PLANNING APPLICATIONS COMMITTEE

12 AUGUST 2026

ADDITIONAL INFORMATION

Title	PLANNING APPLICATION UPDATE REPORT
Ward	Abbey
Planning Application Reference:	PL/26/0415 – Application for Approval of Reserved Matters
Site Address:	Station Hill, Reading, RG1 1NF
Proposed Development	Reserved Matters application pursuant to Outline Planning Permission ref. 192032 for the development of Plots A, B and D at Station Hill, Reading, comprising the erection of two buildings to provide residential units (Use Class C3), including affordable housing, ground floor flexible commercial units (Use Class E), resident amenity space, associated landscaping and public realm works, including Station Hill Gardens and to Station Hill Square, new pedestrian routes, cycle parking, servicing, refuse storage, plant and ancillary infrastructure, with all associated works. Discharge of conditions which are triggered with the Reserved Matters Application including Conditions 54(iii), 63, 75, 76, 86, 94, 95, 96, 99, 107 and 112.

Podium Level - Landscaping

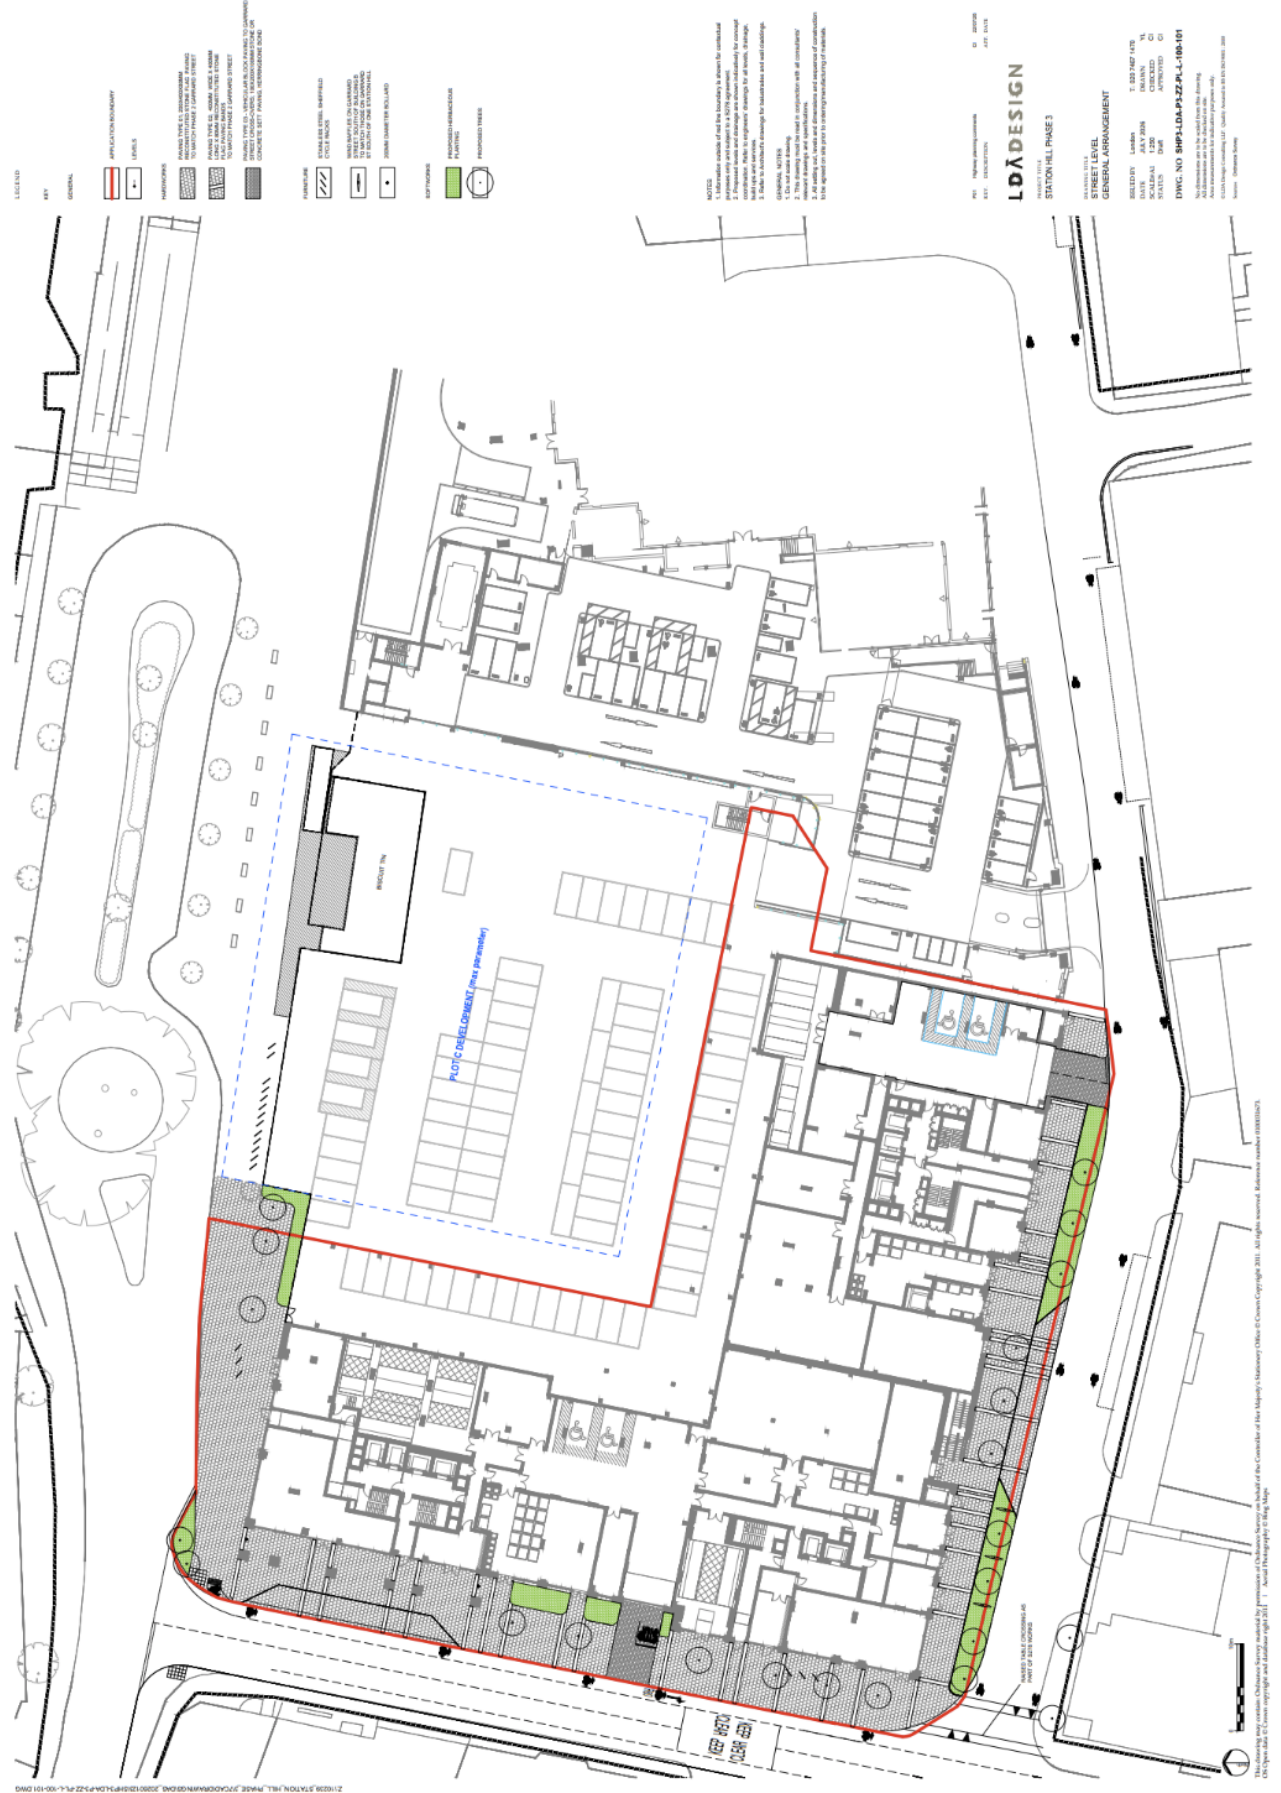
- 3 Sheffield stands (6 spaces) adjacent to the commercial unit on Station Hill which are acceptable.
- 3 Sheffield Stands (6 spaces) adjacent to the commercial unit on Greyfriars Road which are acceptable
- 3 Sheffield Stands (6 spaces) adjacent to commercial unit at Podium Level which in principle are acceptable however only an extract of a plan has been submitted to the Highway Authority to review. The actual plan must be provided to ensure that adequate spacing is provided.

8.	<i>Commercial Visitor Cycle Parking Spaces – lack of detail on podium level provision.</i>	6.88	Cycle parking at podium level. The three stands referred to are shown on the updated drawings and are considered to be acceptable (see Appendix 1).

Image 1 – Landscape areas along Greyfriars Road

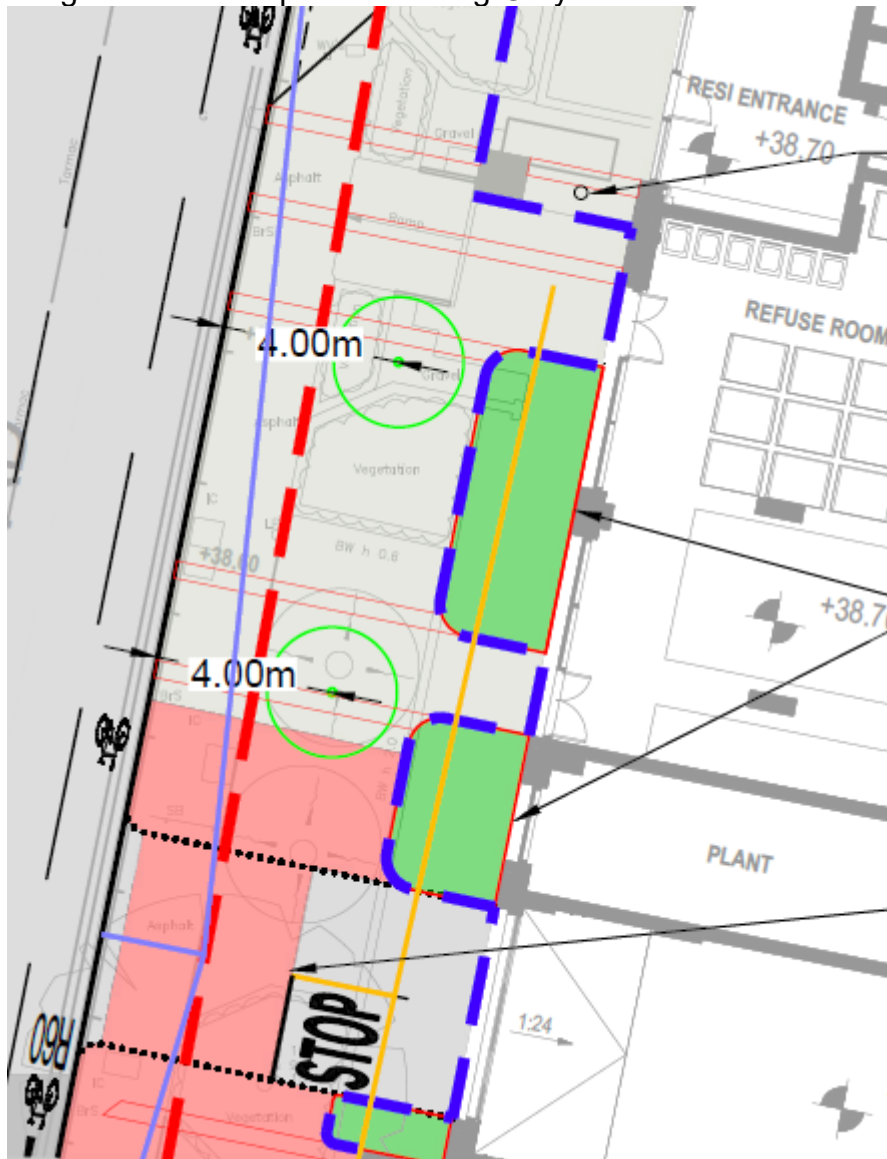
To compensate for the cycle visibility along Greyfriars Road the applicant has proposed a series of 2.7m deep landscaped areas as is illustrated in image 1 below. However, these oversized landscaped areas will create an environment that would be difficult to navigate for those that are blind/partially sighted as they follow the building line. This poor arrangement has been proposed to cover up the cycle visibility concerns discussed later in this consultation response. The Highway Authority would request that this proposed landscape layout should be revised.

3.	<i>Cycle Visibility and Planting Beds – Greyfriars Road</i>	6.73, 6.74	The planting beds have been provided partly in response to earlier Highway Authority comments. New comments regarding the beds causing an obstruction for blind and partially-sighted persons are noted. It remains the case that a well-proportioned (generally 4m wide) footway would be provided west of the

colonnade columns and line of street trees which would provide the most legible and straightforward route for all users. Ultimately it is considered that an appropriate balance is struck between the need to provide a safe and unobstructed route, the need to introduce planting and other visual enhancements and the functional requirements of the buildings as designed. This is set out in the main report. Additional tactile paving or high-contrast paving/markings could be included in the future hard landscaping (see Condition 2) where appropriate.

Image 2 – Diagram illustrating desire line

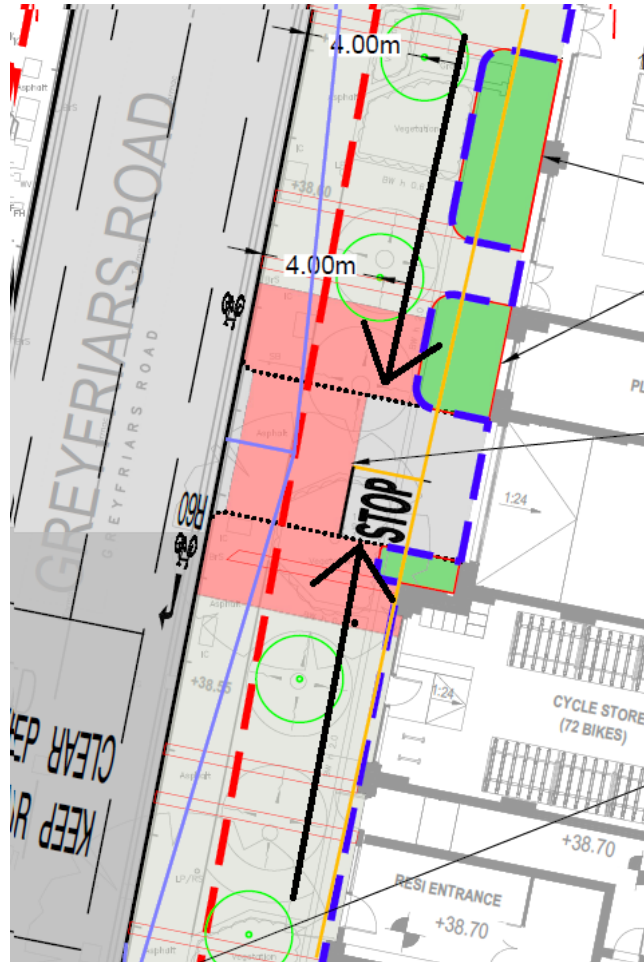
Visibility splays for the vehicle accesses have been illustrated and the Greyfriars Road splay is deemed acceptable. A cycle visibility splay has been illustrated at the access onto Greyfriars Road but the revised layout still illustrates the stop line along the desire line for pedestrians and cyclists. The applicant has stated that the landscaping around the access onto Greyfriars Road pushes cyclists away from building edge and the raised table now provides a desire line for pedestrians away from the stop line. In addition, the applicant has stated that the inclusion of the Sheffield stands to the south of the vehicle entrance will deter cyclists from cycling along the building edge. However, as Image 2 below illustrates by way of the black arrows there is still a desire line for pedestrians and cyclists right adjacent to the building line / landscaping especially as a cycle store, the Sheffield stands and residential entrances are located directly south of the vehicle access.

As had been previously discussed and agreed at the pre-application meeting some form of increased physical measure is required to effectively direct pedestrians and cyclists away from the building edge to ensure that adequate sightlines are provided. It had been agreed that low level landscaping would be provided similar to what has been proposed to the north but a larger area on both sides of the access but this has not been illustrated on the submitted plans. As previously advised a proposal similar to that provided at Image 3 below must be incorporated into the scheme design or the give way line would need to be set back into the site and the building line adjusted to facilitate the visibility splay. It is noted that this would need to be reviewed to take account of the revised stop line.

Notwithstanding the above comments I must advise that Image 2 above does now provide an acceptable visibility splay however the Highway Authority would still contest that will result in conflict between vehicles and pedestrian / cyclists and therefore is fundamentally unacceptable. This is a comprehensive redevelopment of the site and therefore there is no reason why a compromise in design standards would be necessary. The Highway Authority therefore fundamentally objects to the development given that it fails to provide an acceptable pedestrian and cycle route along Greyfriars Road contrary to National standards contained within LTN 1/20, the NPPF and the Reading Borough Local Plan.

4.	<i>Visibility Splays at Greyfriars Road entrance</i>	6.73	The request to further increase the extent of the planting beds and adjust the stop line is noted. This has already been addressed in the main report (para. 6.73). Further enlargement of planting beds would add further undesirable obstructions to the footway. It is also important to consider that the access would serve a very limited number of spaces – 2 disabled parking bays and a single space for service vehicles. The scope for any conflict is therefore also limited. The access is designed as a raised crossing with the footway/cycleway continuing at the same level and vehicles passing over the raised table. This provides a clear indication to the few drivers that do use the access that they must be alert to and give way to any pavement users and proceed with due care. This is considered to be an appropriate design response in this urban context.
